MEETING AGENDA

Planning and Zoning Commission

Village of Homewood

APPLICANT	Mahmoud Essa
ACTION REQUESTED	Site Plan Review, Special Use Permit
ADDRESS	18240 Harwood Avenue
PIN	29-31-312-007; 29-31-312-012; 29-31-312-020

1 PROPOSED BASEMENT PLAN
1/8" = 1'-0"

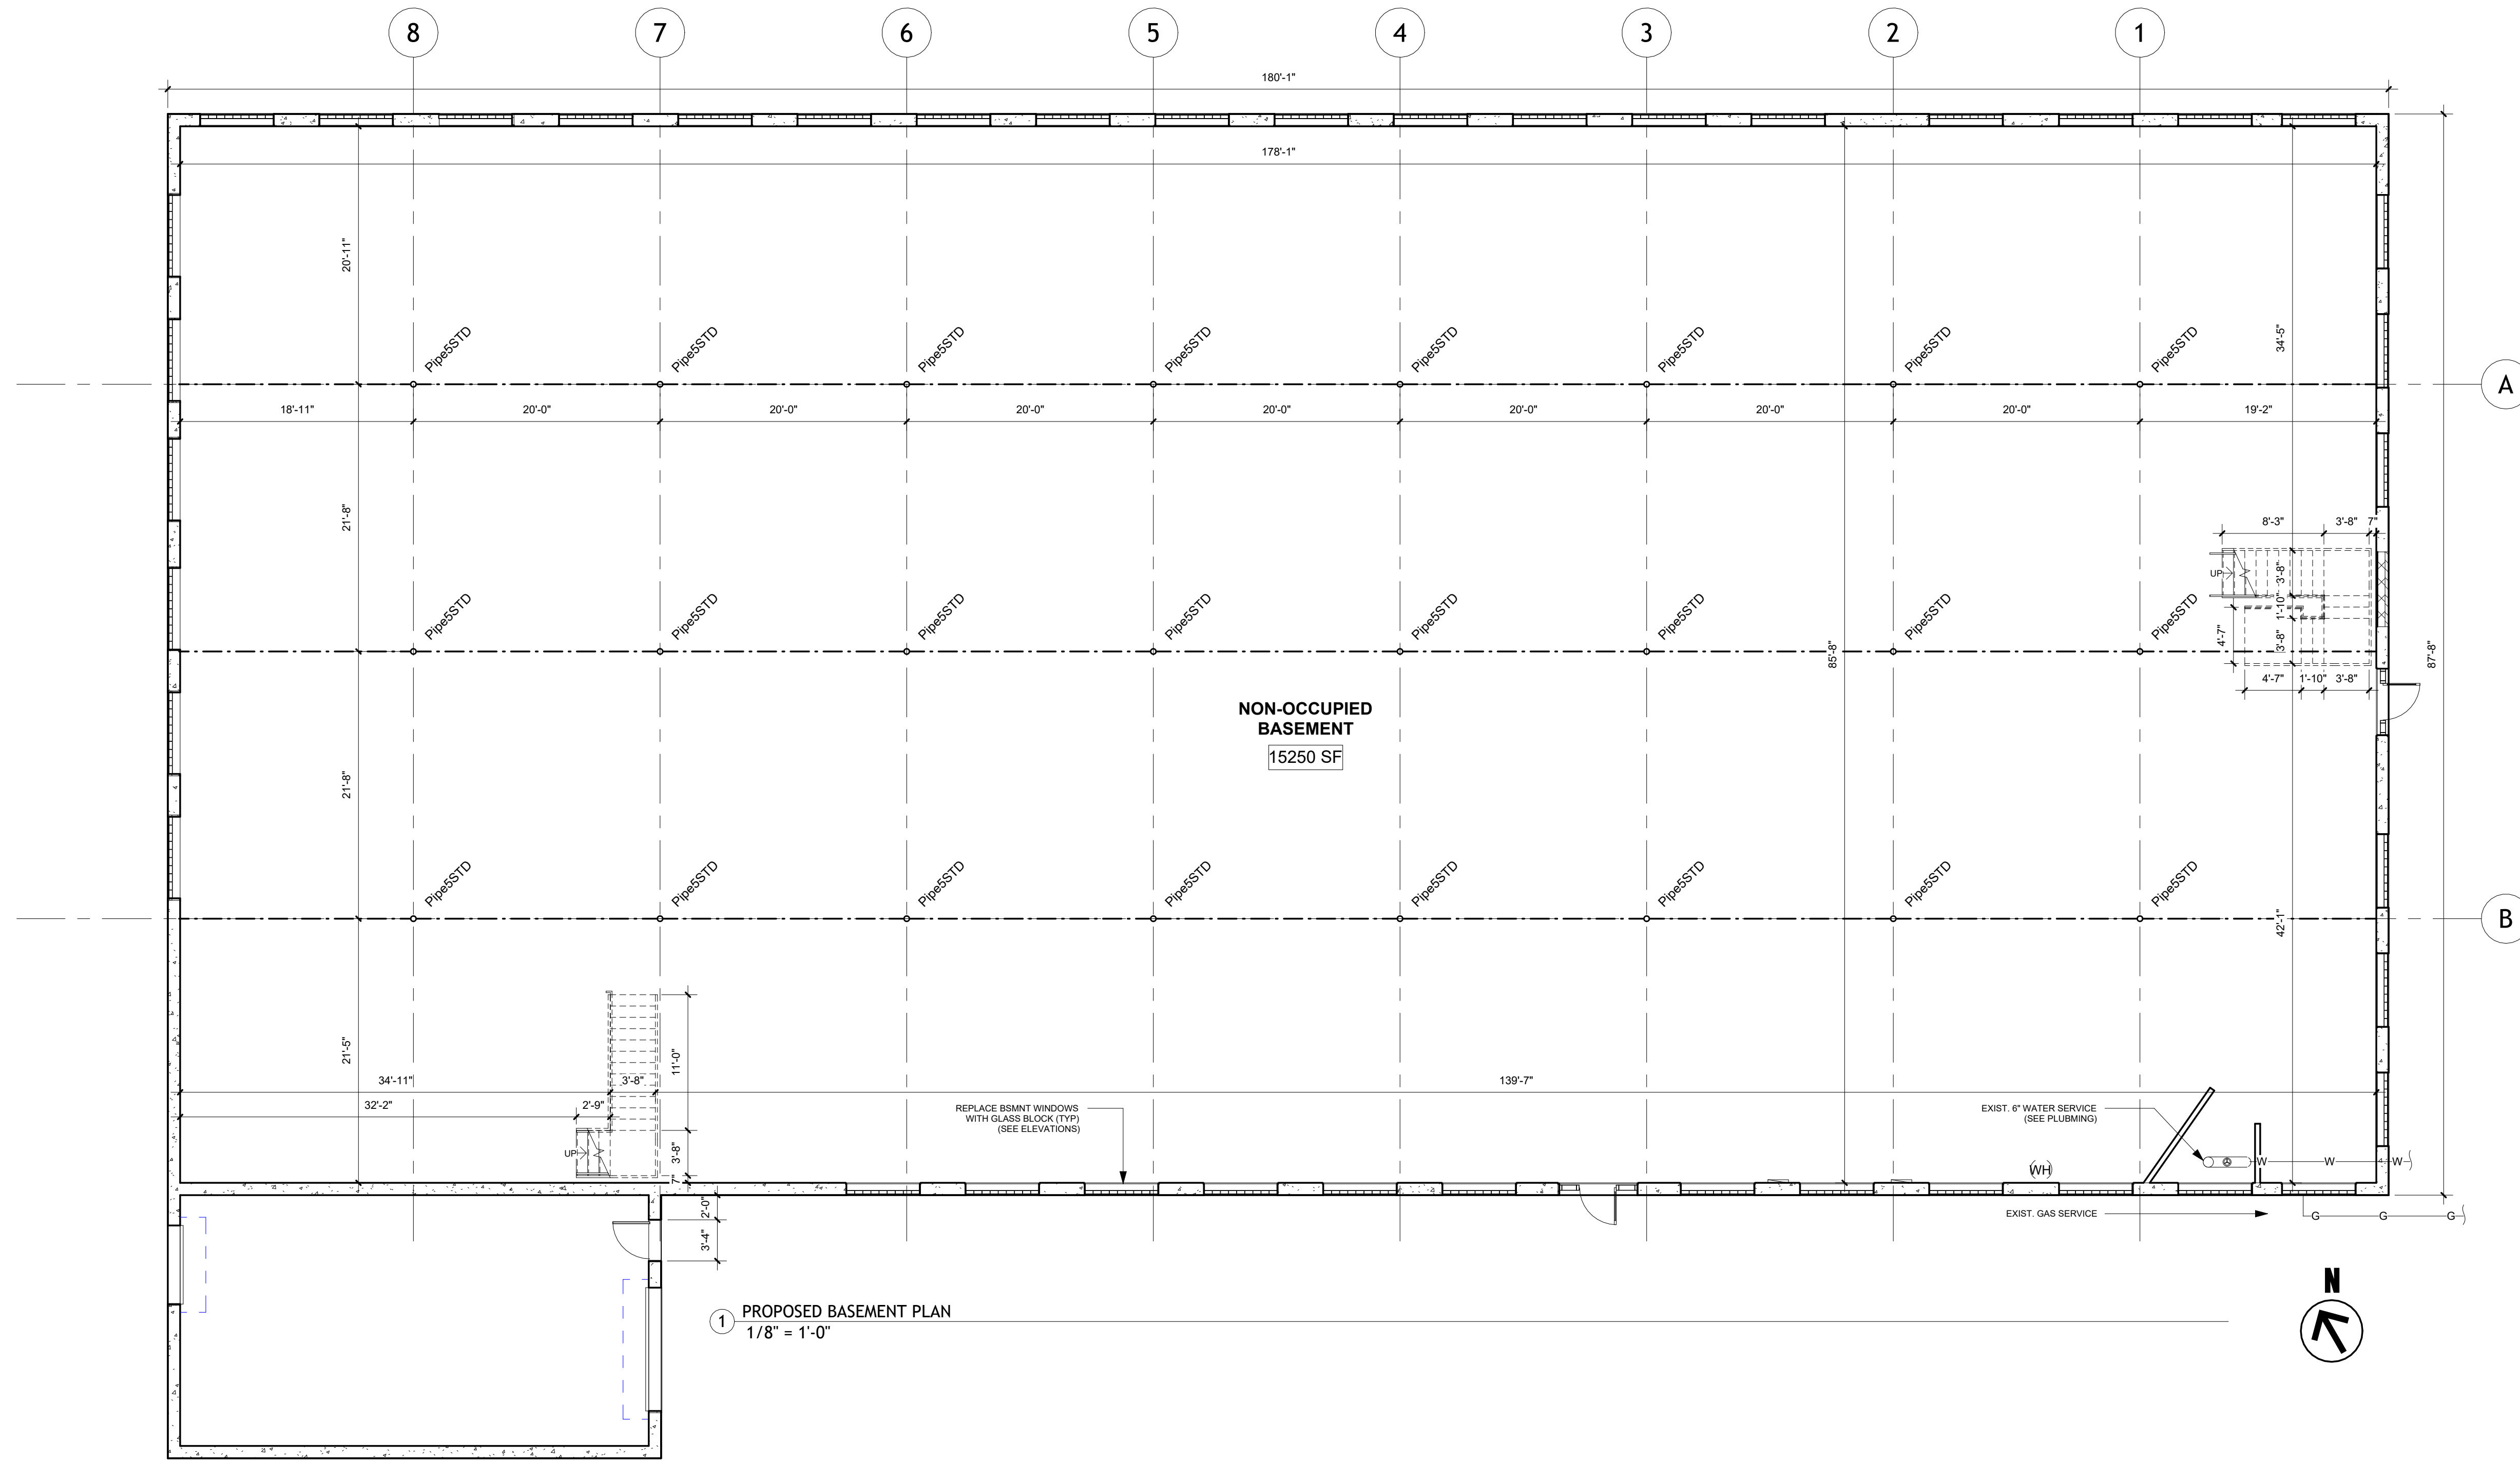
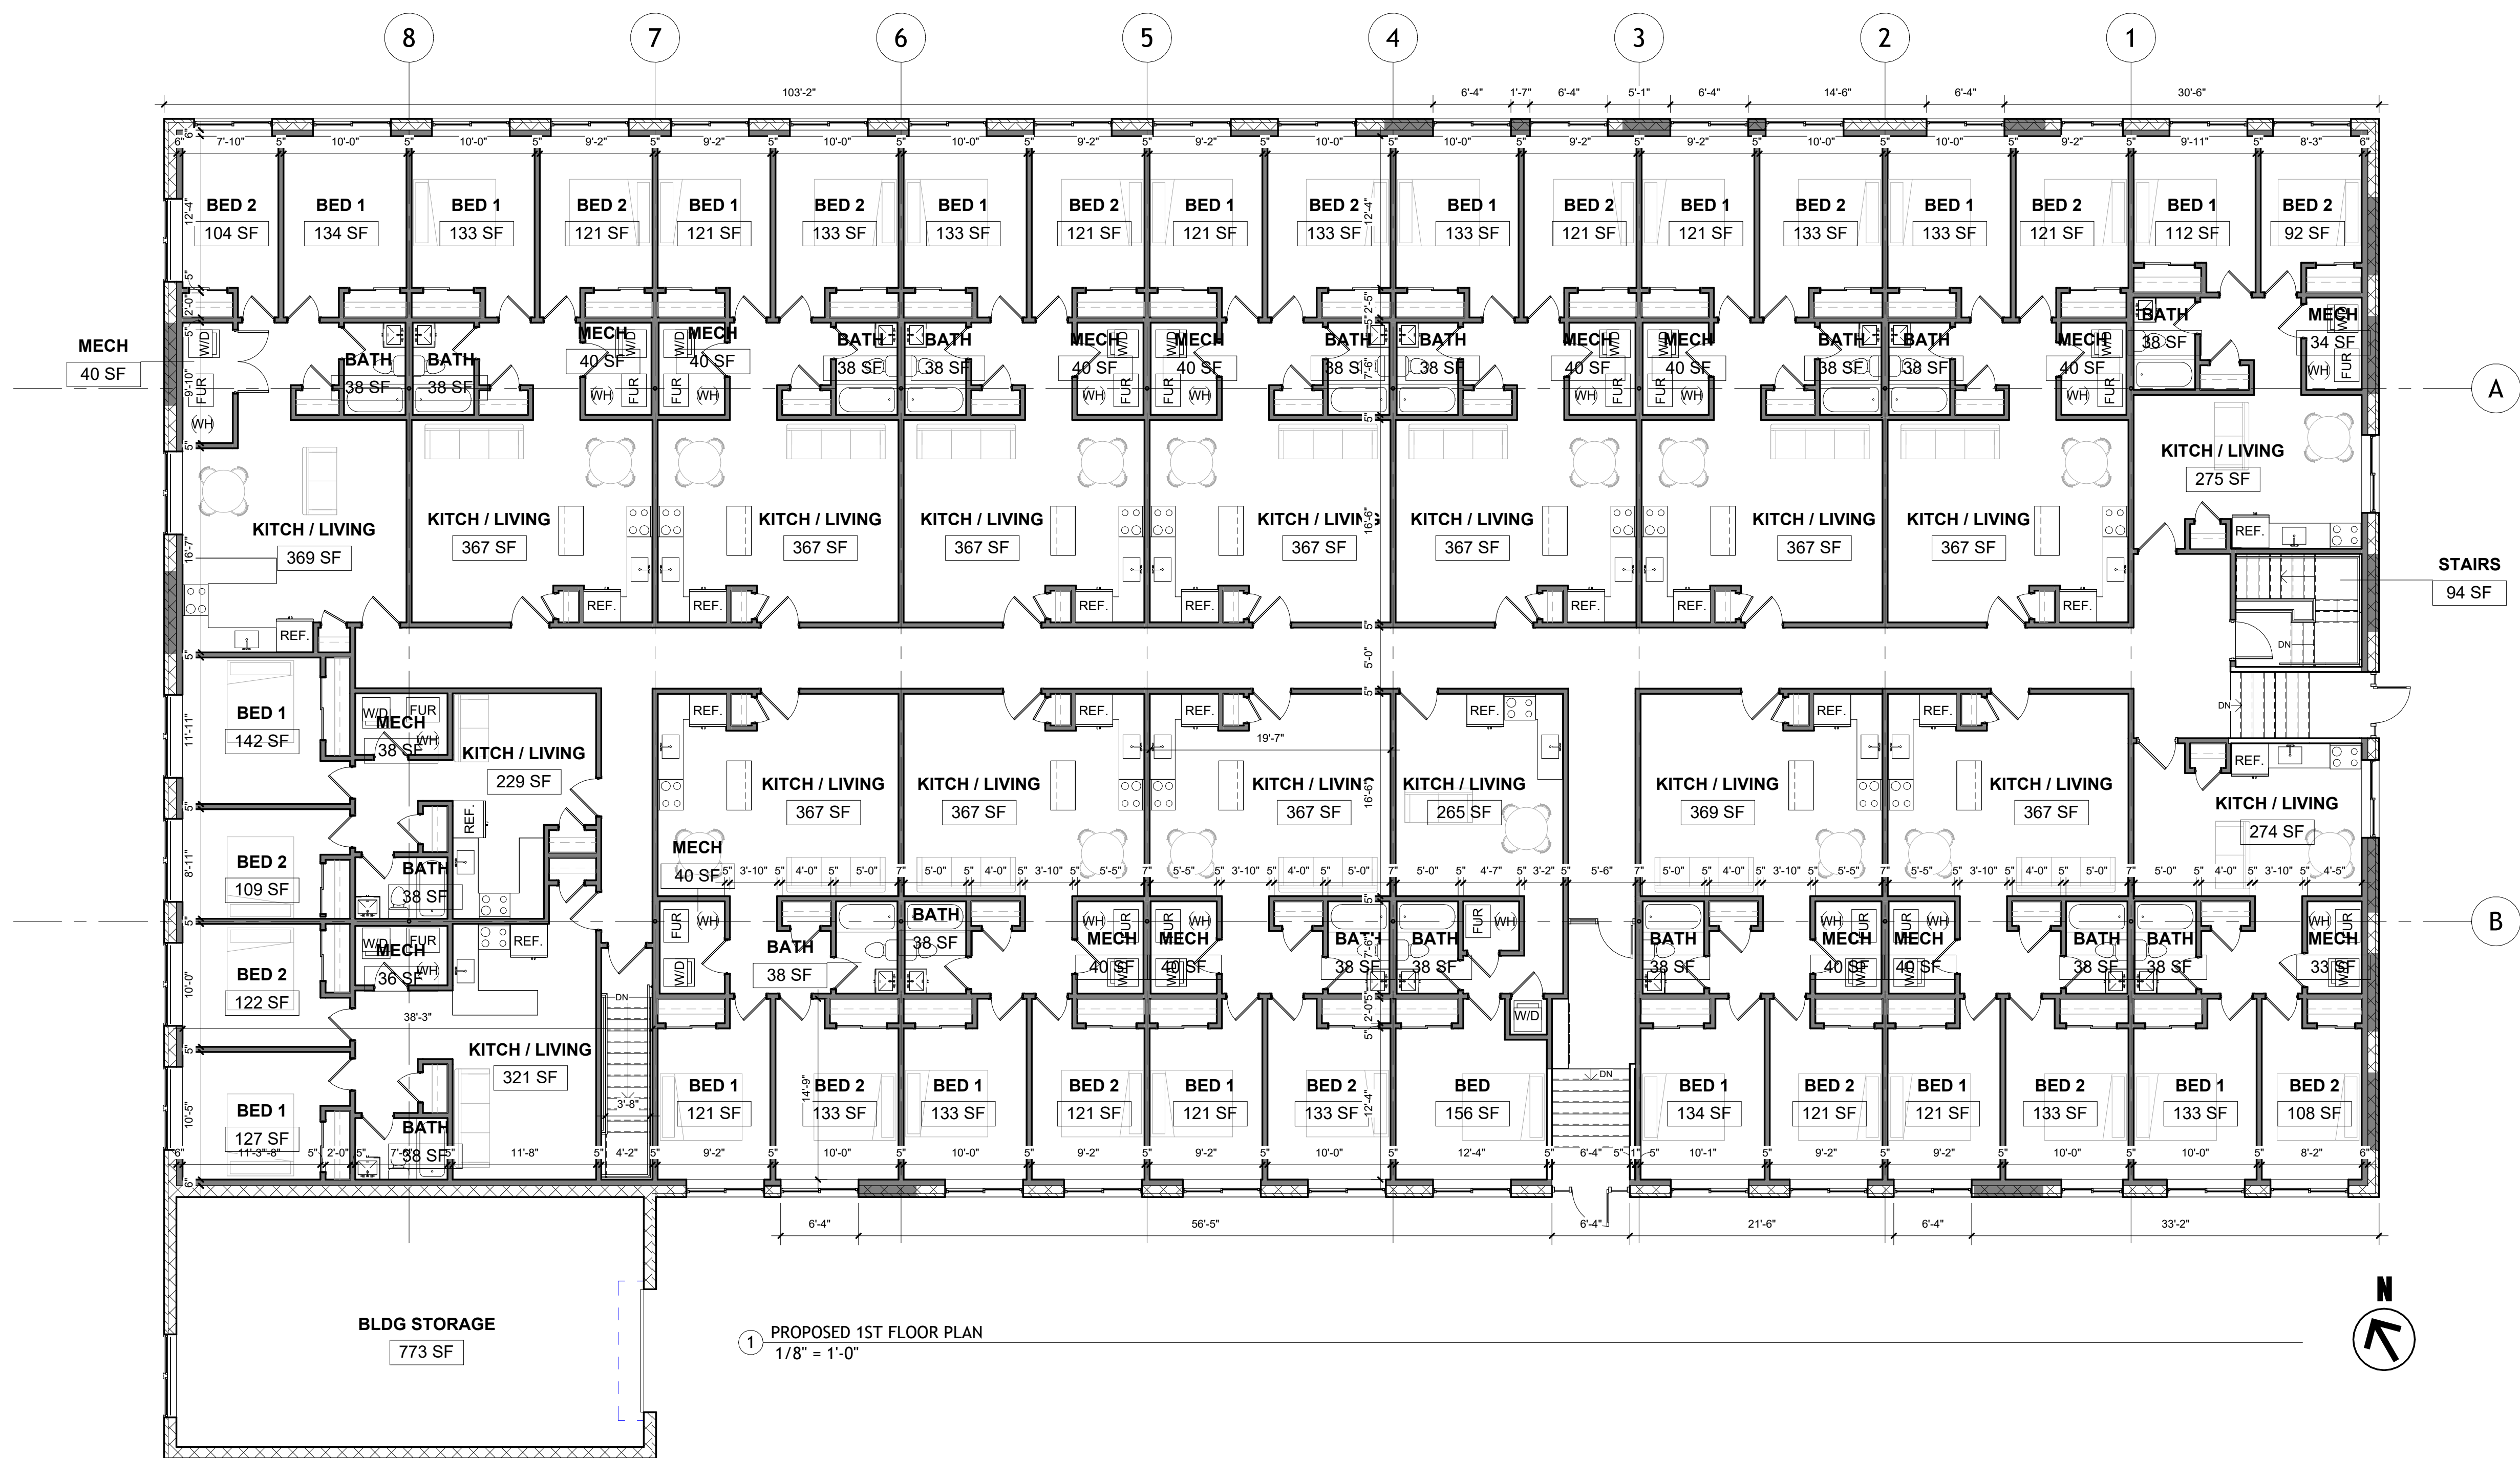
Two points of egress are provided (front, and side) to ensure compliance with local fire and building codes. A third point of egress (rear) was discussed with the Site Plan Review Committee but is not indicated in the floor plans. **The staff recommends a condition of approval requiring revised floor plans showing a third access point in the rear of the building to meet adopted fire and building codes.** See *Recommended Planning and Zoning Commission Action*.

The applicant has stated that a lift will be installed to provide ADA accessibility within the building as required by building code. The lift is proposed near the southern entrance of the building. The ADA-accessible parking spaces are located adjacent to this entrance. The current version of the site and floor plans do not indicate the location of this lift. This entrance is also proposed to be accessed by stairs without a ramp or access device compliance with the 2018 Illinois Accessibility Code. **The staff recommends a condition of approval requiring the applicant to provide details of the proposed lift and ADA access to the building.** See *Recommended Planning and Zoning Commission Action*.

1. A revised floor plan indicating the location of a) interior improvements to provide ADA-compliant access, and b) a third egress point as required for the proposed use, shall be submitted and approved by the Chief Building Inspector before the issuance of building permits;
2. A revised site plan indicating the location of a) exterior improvements to provide ADA-compliant access to the southern entrance of the building, and b) any exterior improvements required for the third point of egress to the building, shall be submitted and approved by the Chief Building Inspector before the issuance of building permits;
3. A structural report shall be completed, filed, and approved by the Chief Building Inspector before the issuance of building permits;
